STATE OF NORTH CAROLINA
DEPARTMENT OF TRANSPORTATION

Subject: **Application for Modification of the Section 404 Individual Permit, Section 401 Water Quality Certification, and Riparian Buffer Certification** for the Continuation of Greensboro-High Point Road (SR 4121) on New Location in Guilford County, Federal Aid Project No. STP-4121(1), Division 7, TIP No. U-2412 A, Debit \$570 from WBS 34802.1.1.

**Minutes from the Interagency 4C Permit Drawing Review Meeting
U-2412A in Guilford County
September 21, 2017
NCDOT Century Center
10:00 AM – 12:00 PM**

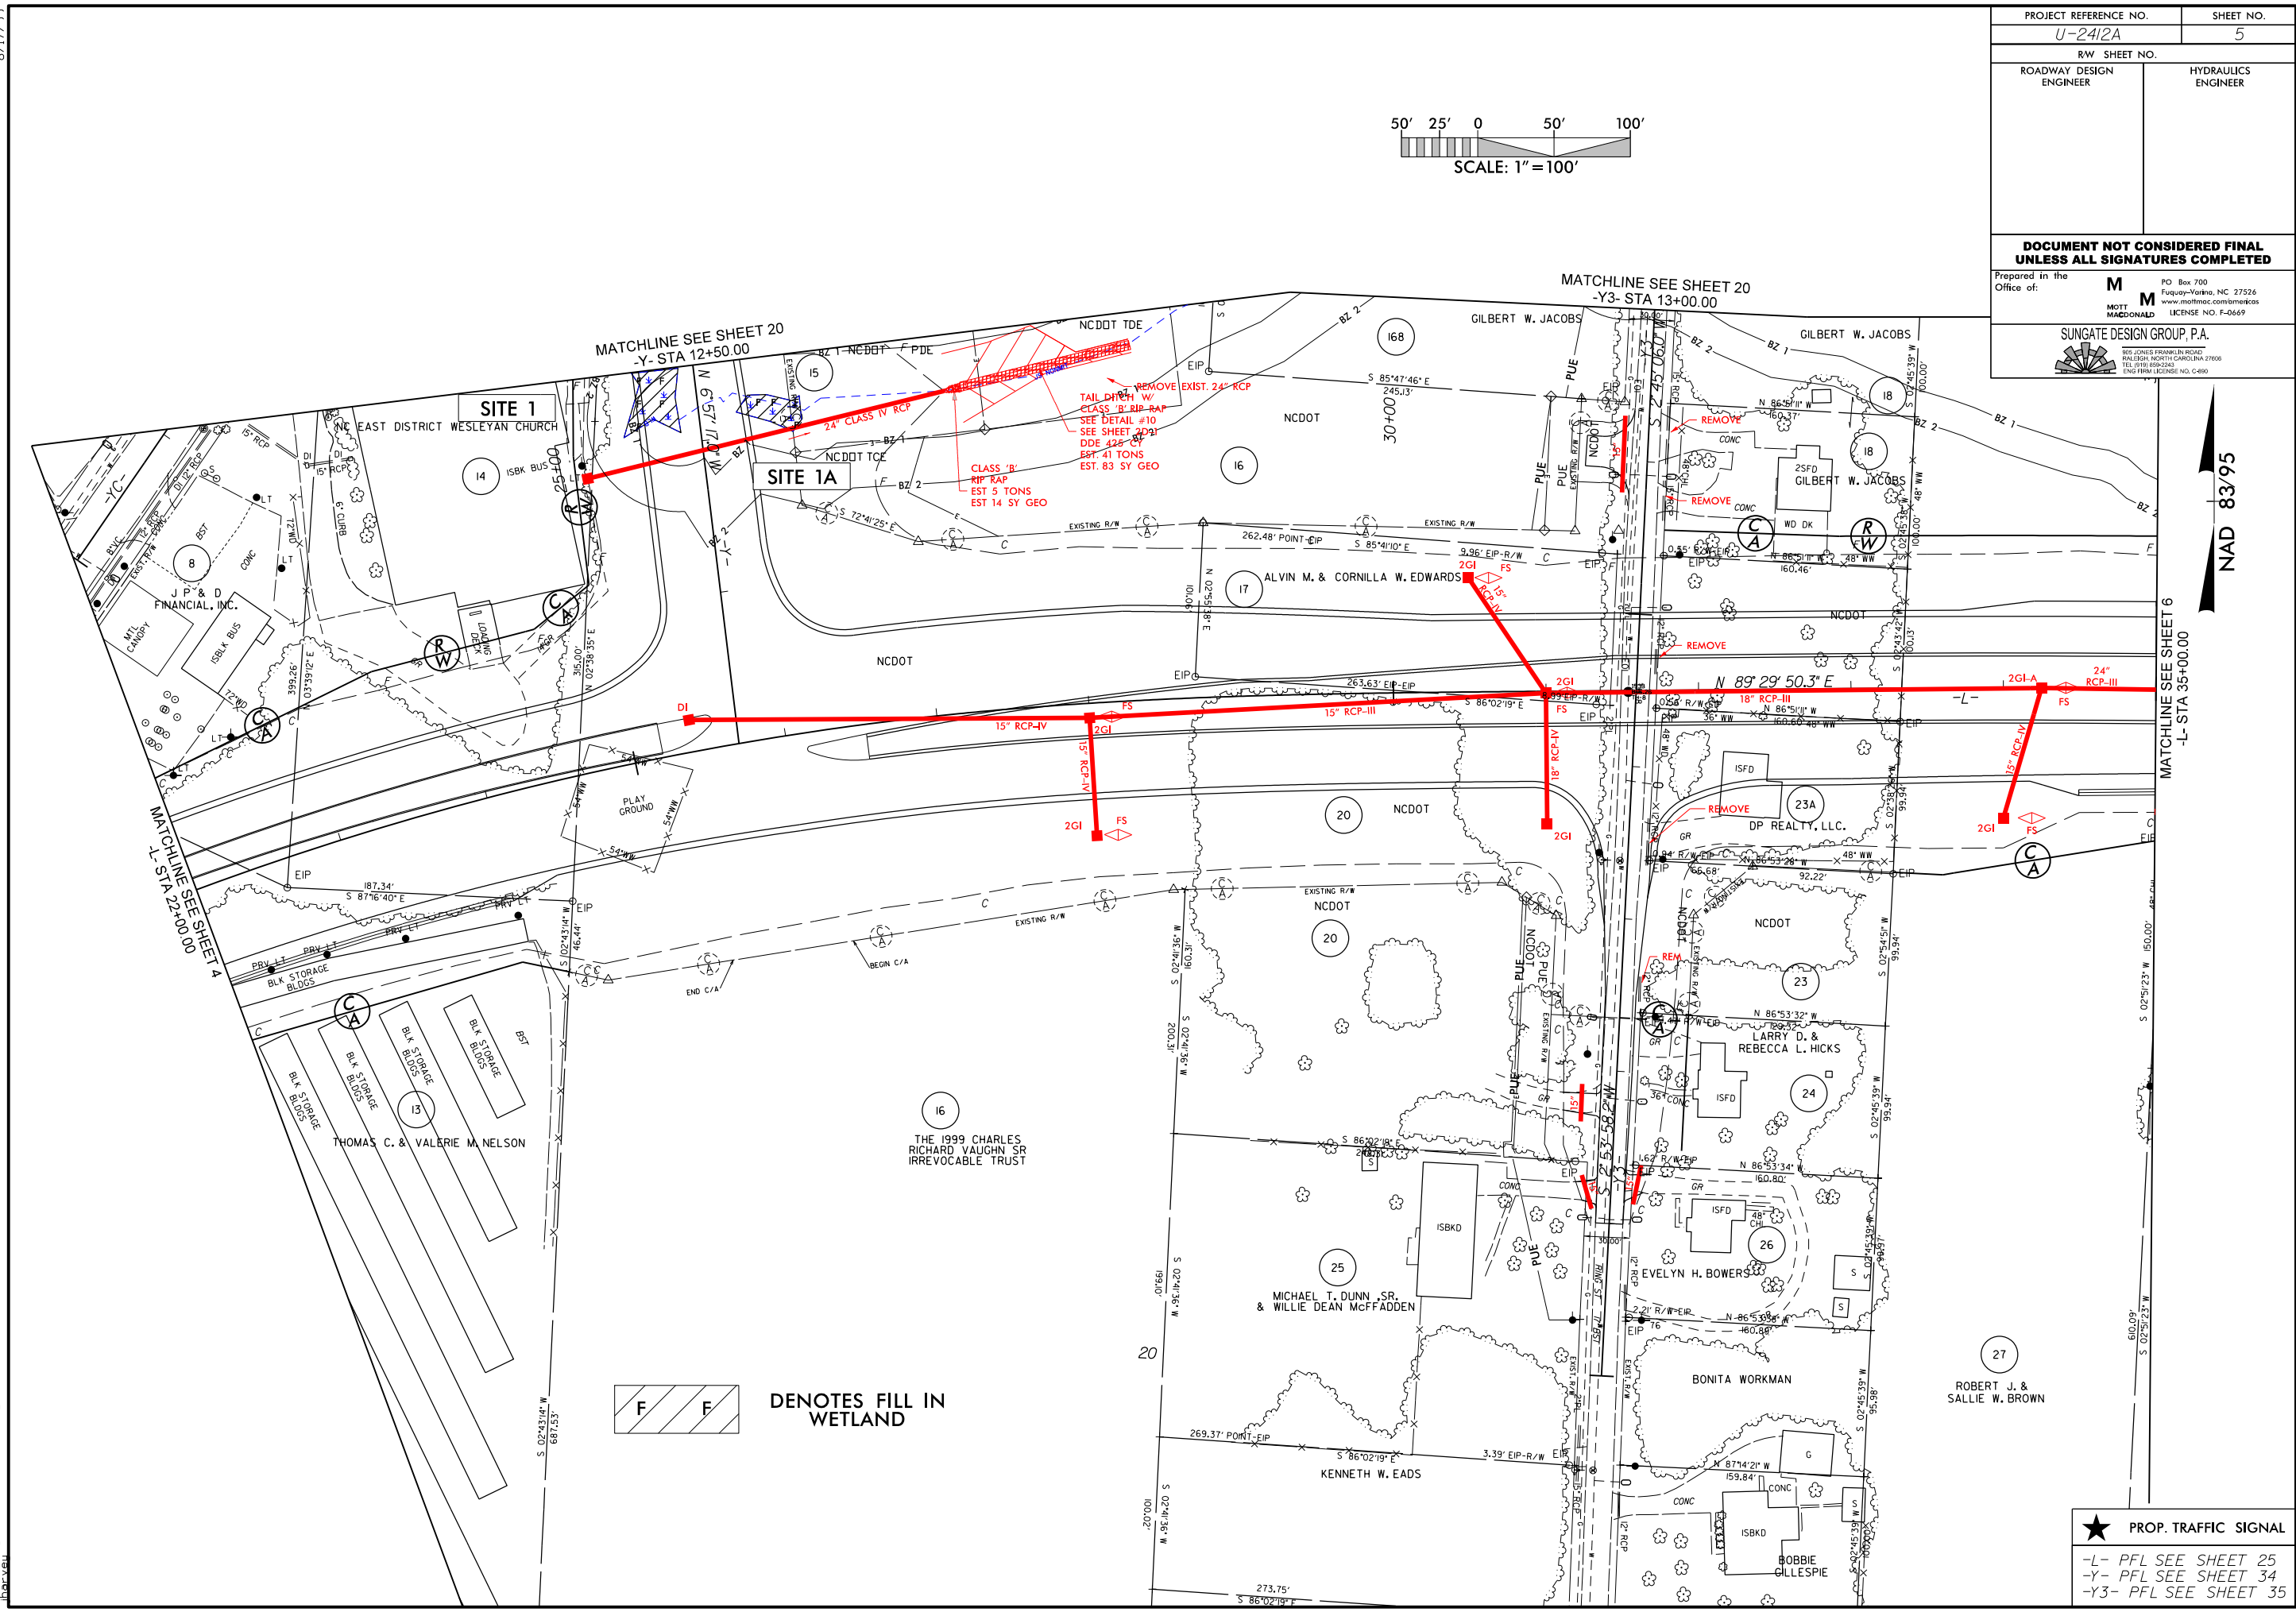
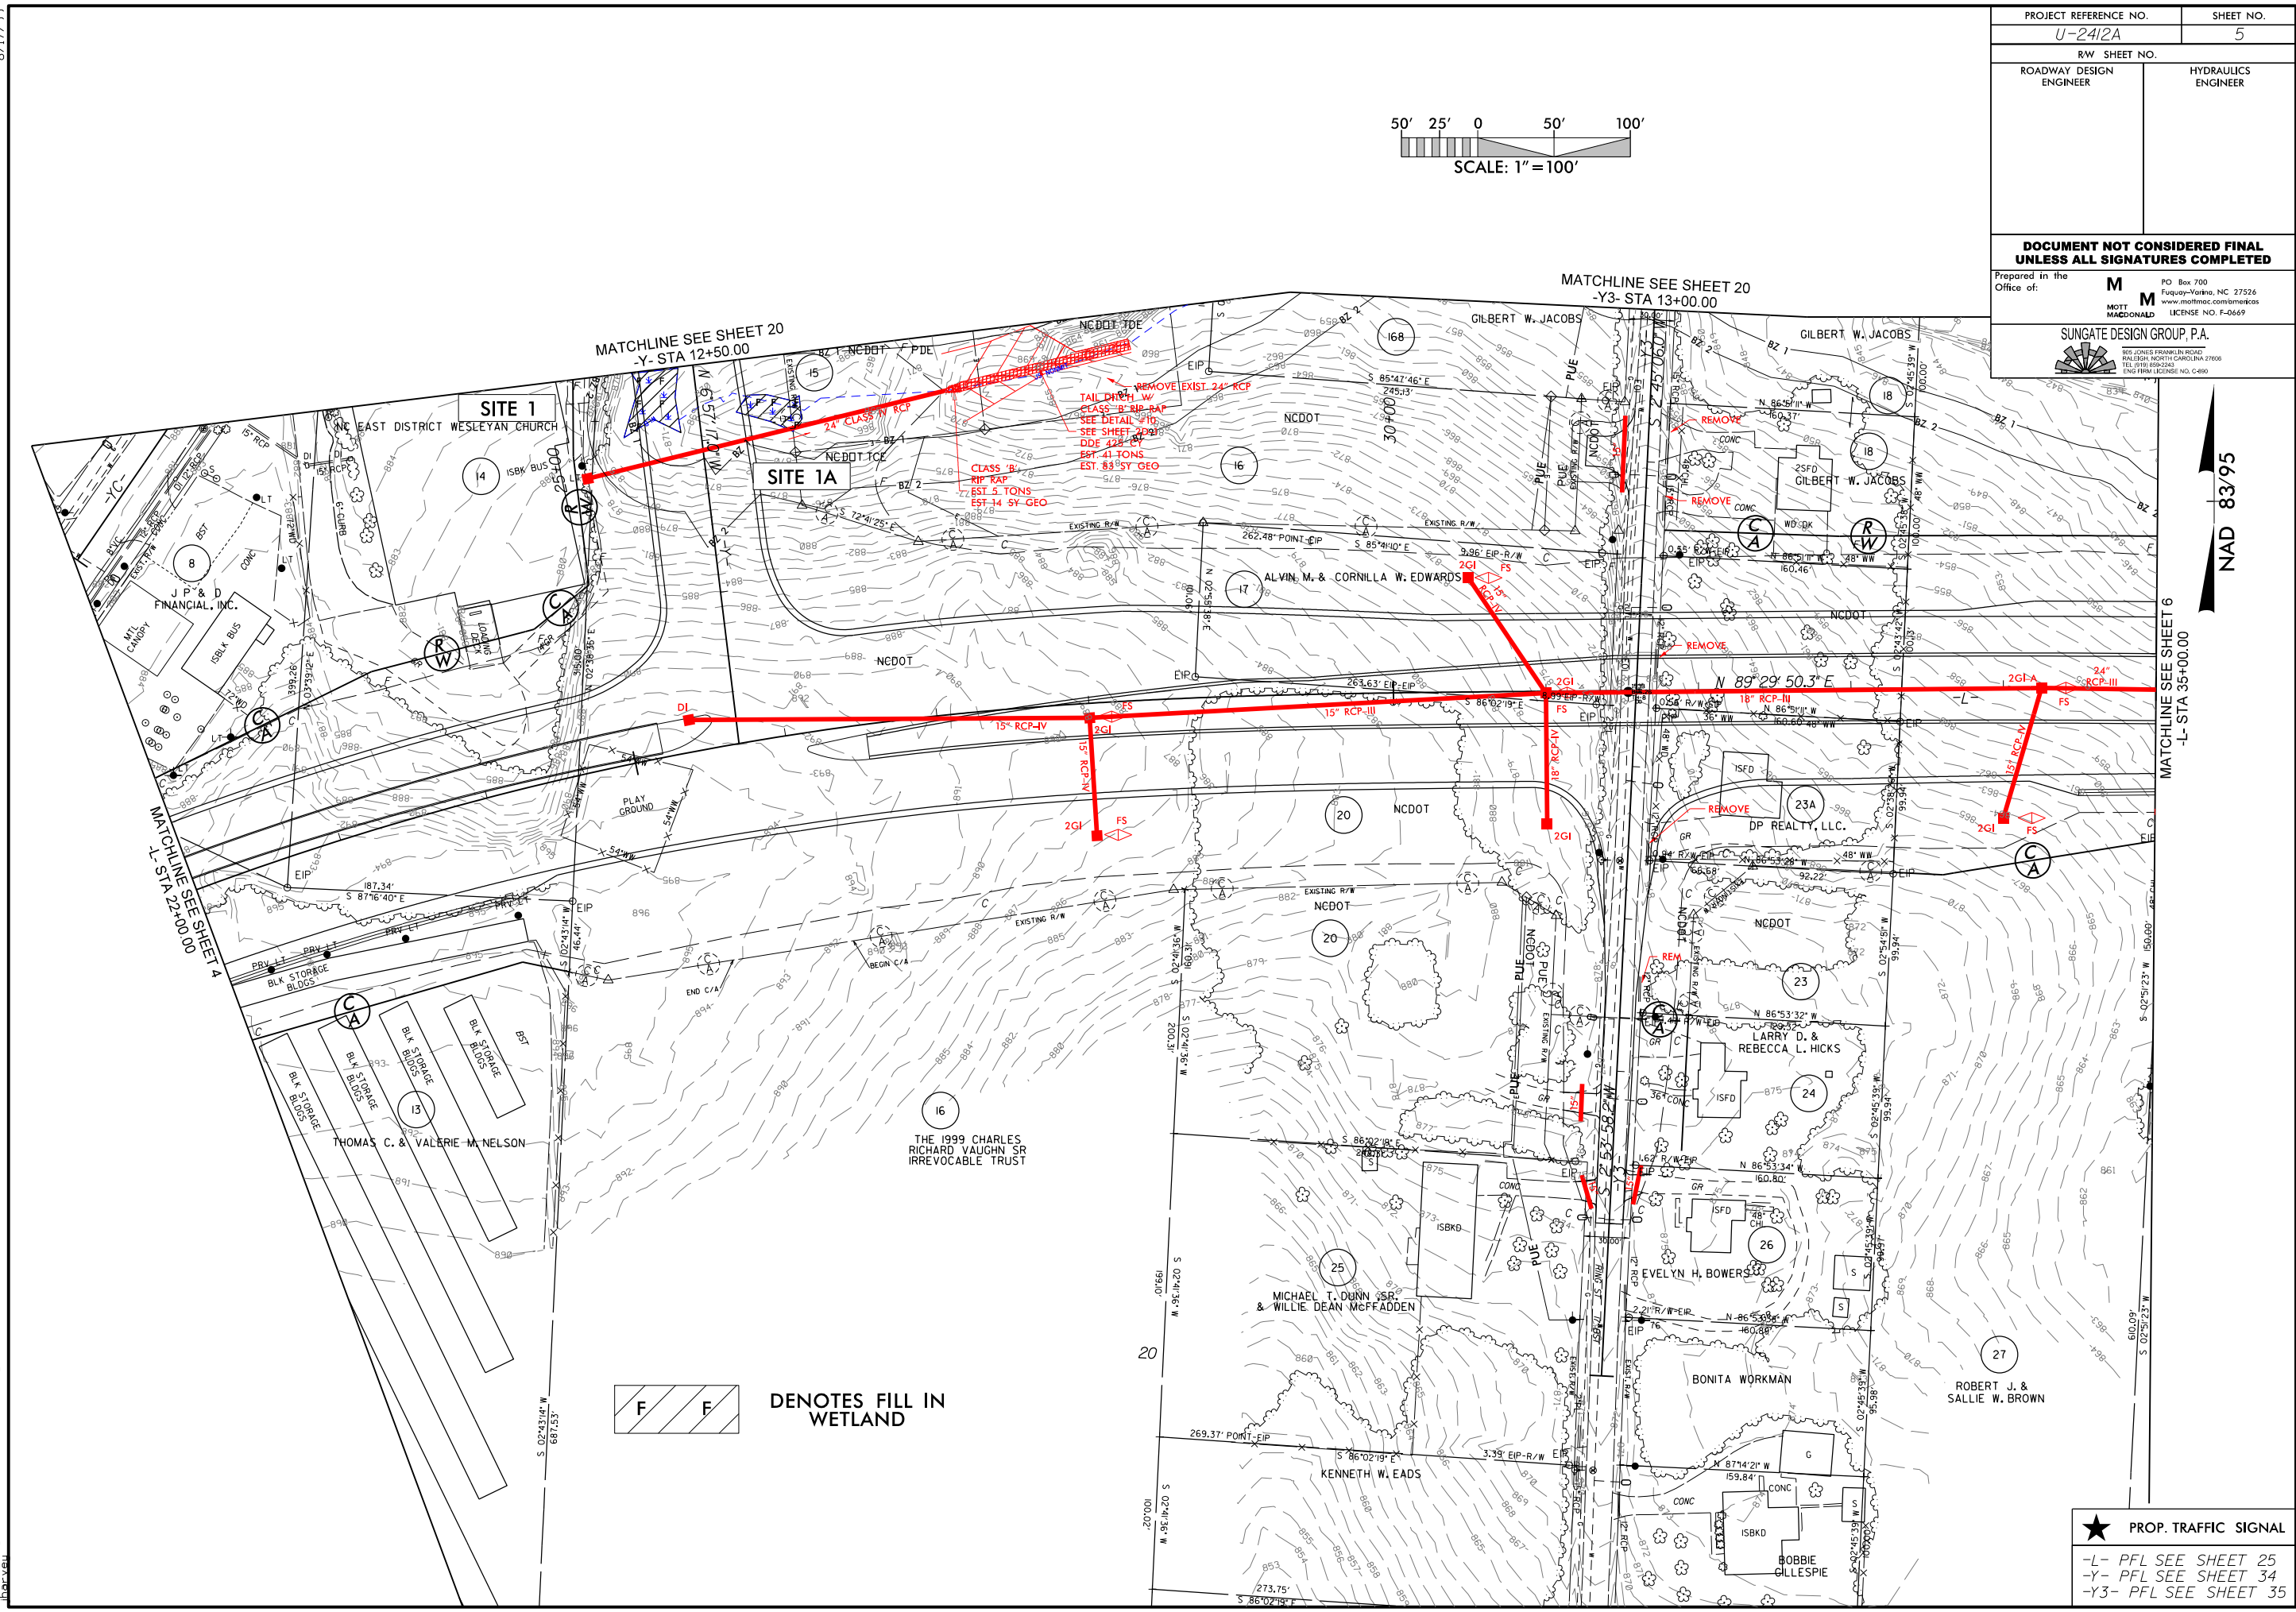
Site 1 (Plan Sheet 5):

- Remove ephemeral stream line.
